# Access Compliance Report

## Public Rights-of-Way

Intersection ID: 30554	Main Street: GREENCREEK_DR	Cross Street: SMITH_BOYD_RD	Location: SW
ADA ID: 97DFF4B99751	Ramp Type: Perp	Initial Pass/Fail: Fail	Overall Compliance: No
Severity Score: 50			
Codes/Mitigation Info/Possible Solution		Field Measurements/Component Compliance

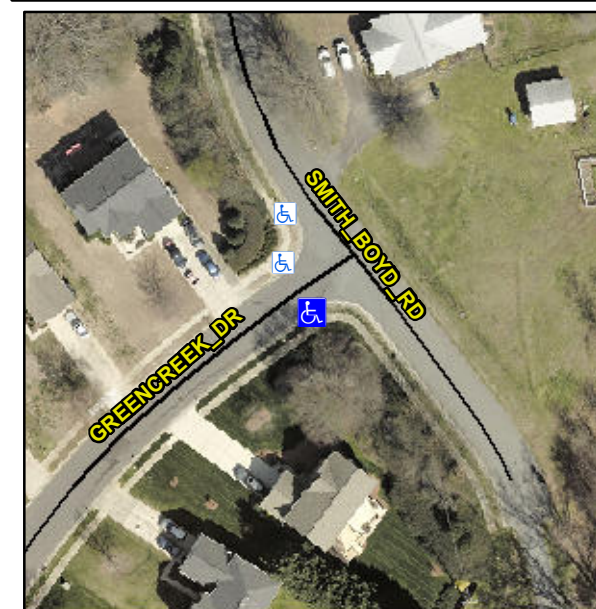
**Not Found, R304.2.2, R304.5.3**

Compliance	Description	Data	Compliance	Description	Data
N/A	Ramp Length (in)	48.0	No	Ramp Slope (%)	14.7
Yes	Ramp Width (in)	48.0	No	Ramp XSlope (%)	14.9
N/A	Flare Type LT	N/A	N/A	Flare Type RT	N/A
N/A	Flare Slope LT (%)	N/A	N/A	Flare Slope RT (%)	N/A
N/A	Flare Traversable LT?	N/A	N/A	Flare Traversable RT?	N/A
N/A	Landing Length (in)	N/A	N/A	DWS Provided?	N/A
N/A	Landing Width (in)	N/A	N/A	DWS Contrast?	N/A
N/A	Landing Slope (%)	N/A	N/A	DWS Length (in)	N/A
N/A	Landing X Slope (%)	N/A	N/A	DWS Full Width?	N/A
N/A	Landing Curb? (Y/N)	N/A	N/A	DWS Offset (in)	N/A
N/A	Shared Landing?	N/A			
N/A	Gutter Ponding?	N/A	N/A	Gutter Slope (%)	N/A
N/A	Gutter Lip Ht (in)	N/A	N/A	Gutter X Slope (%)	N/A
N/A	Painted X Walk1?	No	N/A	Painted X Walk2?	N/A
	X Walk 1 Direction	To NW		X Walk 2 Direction	N/A
N/A	X Walk 1 Width (in)	N/A	N/A	X Walk 2 Width (in)	N/A
	X Walk 1 Slope (%)	5.1		X Walk 2 Slope (%)	N/A
	X Walk 1 X Slope (%)	3.6		X Walk 2 X Slope (%)	N/A

**Remove & Replace Entire Ramp.**
